**BYRON STATION
UNITS 1 AND 2**

DOCKET NOS. STN50-454 AND STN 50-455

JULY 1974

**UNITED STATES ATOMIC ENERGY COMMISSION
DIRECTORATE OF LICENSING**

Fig. 3.2. Water Usage Flow Diagram. Modified from applicant's Environmental Report.

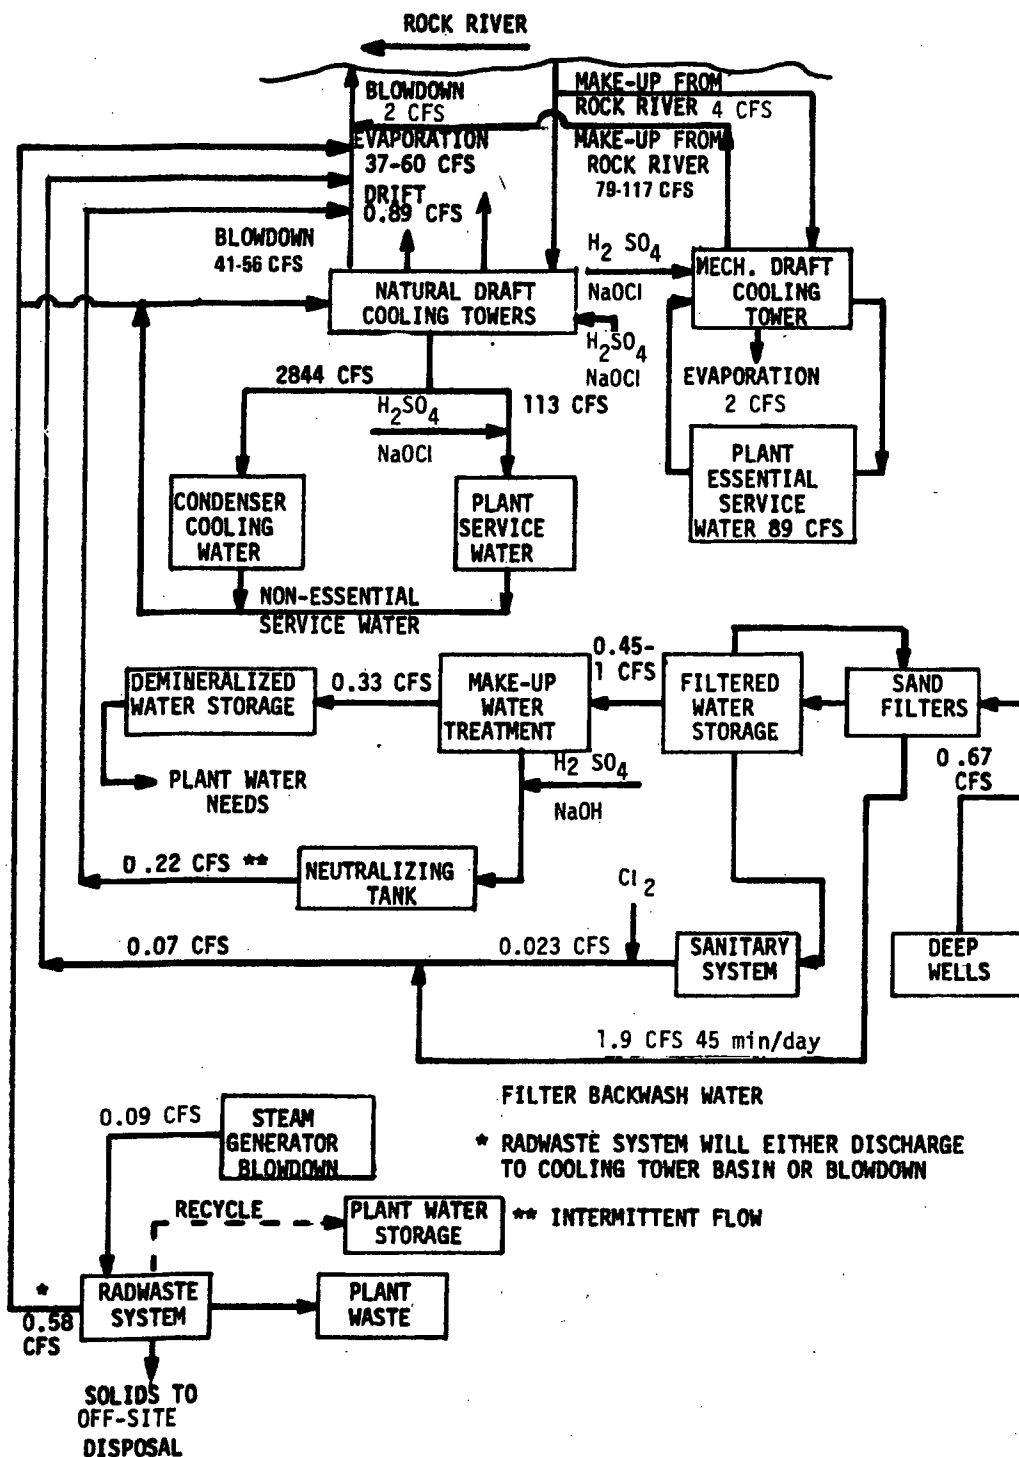
3. With regard to chemical wastes, the design should include provisions for sampling of each stream identified in Figure 3-2, including: radwaste system discharge, sanitary system discharge, neutralizing tank discharge, and cooling tower blowdowns. The details of such design provisions should be included in the final statement.

Fig. 3.7. Gaseous Waste Treatment Systems.

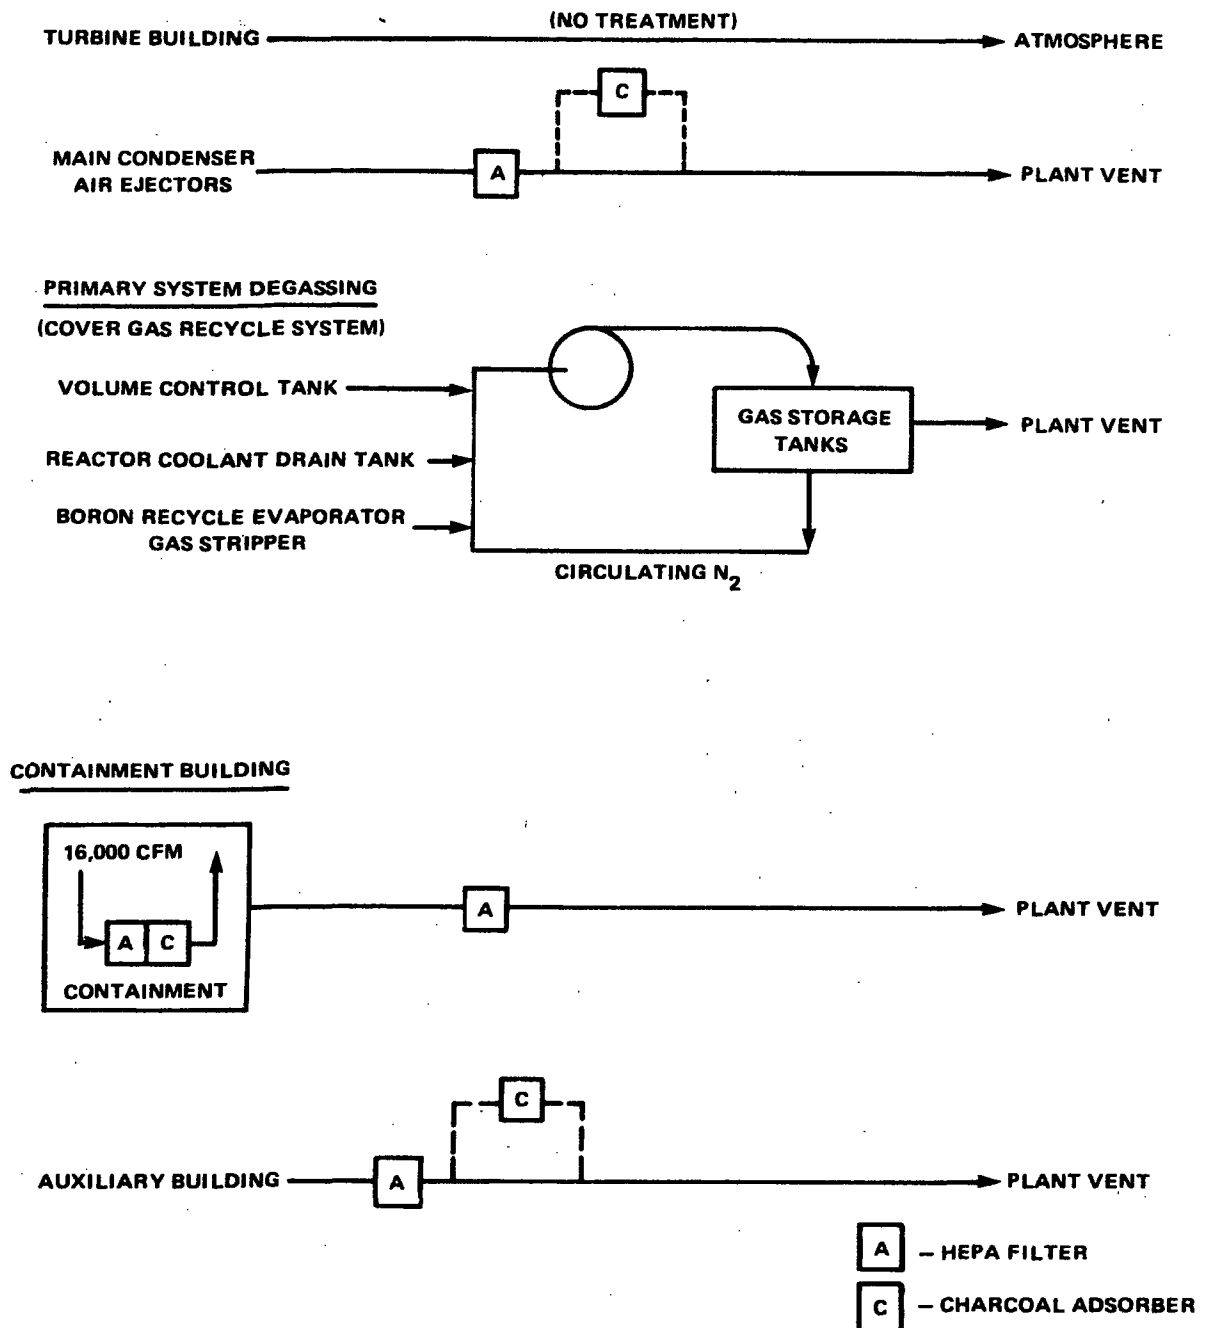
8. On page 5-16 of the draft statement, the AEC staff states that there will be no treatment of the off-gases from the main condenser vacuum pump. This statement is confirmed by Figure 3.7 on page 3-18 and applicant's Environmental Report. But on page 3-20, a DF of 10 for charcoal adsorbers is assumed for air ejector offgases. This discrepancy should be explained in the final statement.

The off-gases from the main condenser vacuum pump are processed through HEPA filters and charcoal traps if necessary. The text and Figure 3.7 were corrected to eliminate the discrepancy. (See Sect. 3.5.2)
